**TOWN OF BAY HARBOR ISLANDS
PLANNING AND ZONING BOARD**

FINAL AGENDA

PROPOSED RENOVATION AND ADDITION TO EXISTING RESIDENCE

Subject: Addition and Renovation to an Existing Single-Family Residence
9424 W. Broadview Drive
Bay Harbor Islands Acct. No.: MB20XX-XX
MMPA Acct. No.: 01-0702-1059

PROPOSED NEW CABANA FLOOR PLAN
SCALE: 1/4"=1'-0"

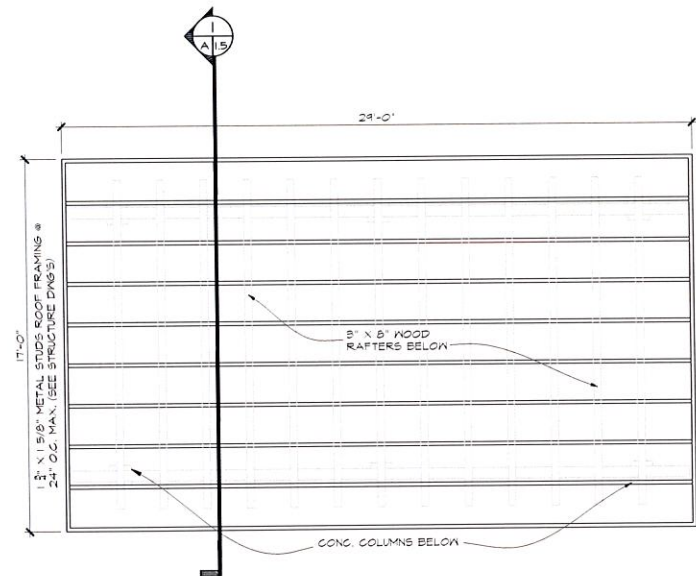
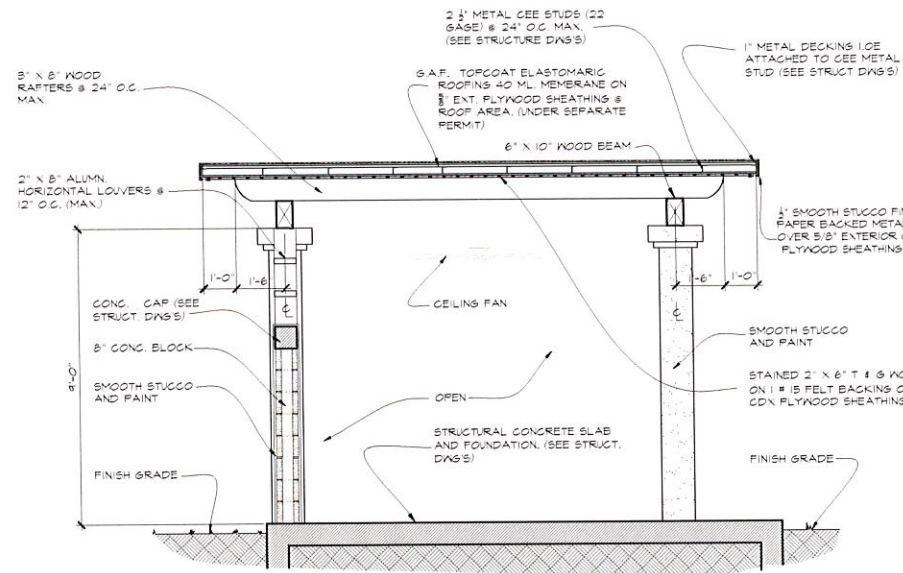
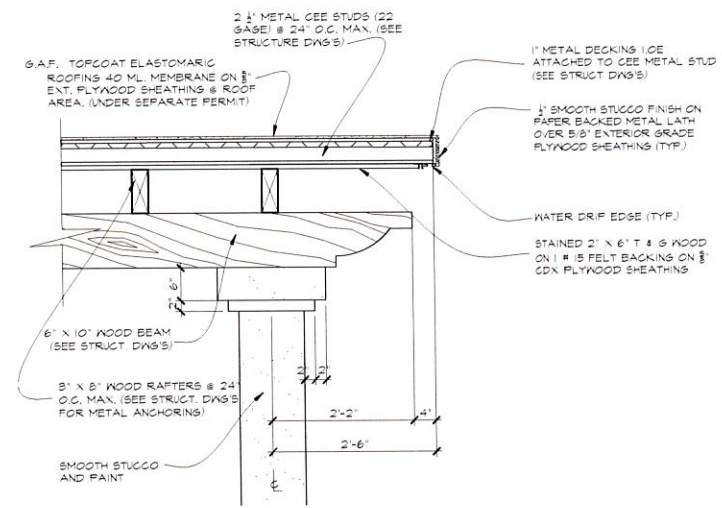
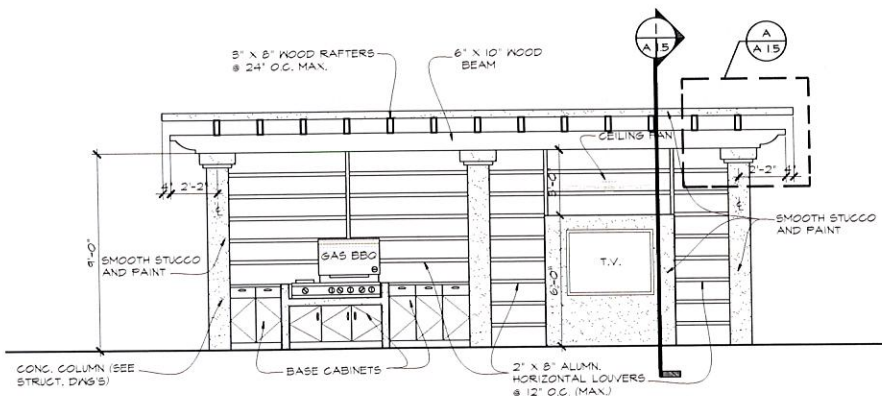
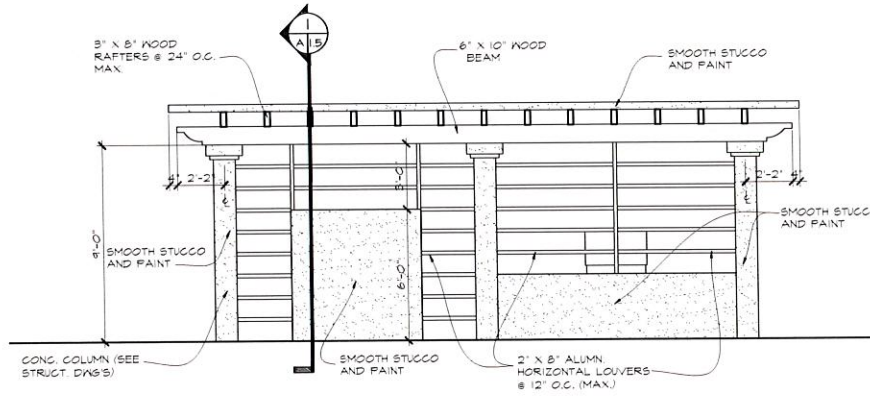
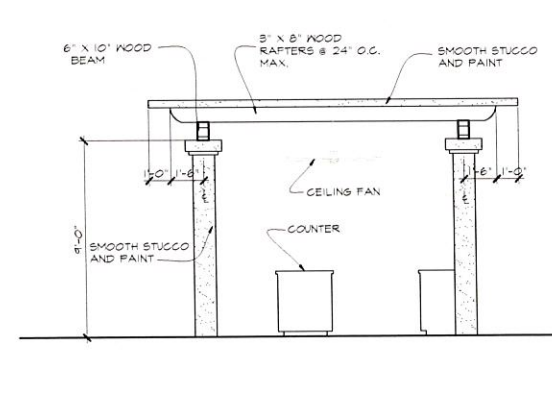
It should be noted that the proposed plans show a pool cabana structure in the rear of the property. Per Section 23-12(15)(e)(iii), certain open, airy and decorative structures such as pool cabanas may project into the rear and side yard setback areas (or into the front and side yard setback areas of waterfront lots) to a point no closer than five feet from the lot line or the seawall for waterfront lots, subject to written approval by the Planning and Zoning Board. The applicant is requesting Planning and Zoning Board approval for the cabana structure per Sec. 23-12(15)(e)(iii).

- 1) This approval is based on the plans prepared by Choeff Levy Fischman Architecture and Design dated submitted electronically to MMPA on September 22nd, 2017 with any modifications required by the PZ Board. All modifications to the above plans shall be reviewed by Town staff and may require re-approval by the PZB if felt to be substantial.
- 2) The PZ Board finds the pool cabana structure design / location is acceptable.
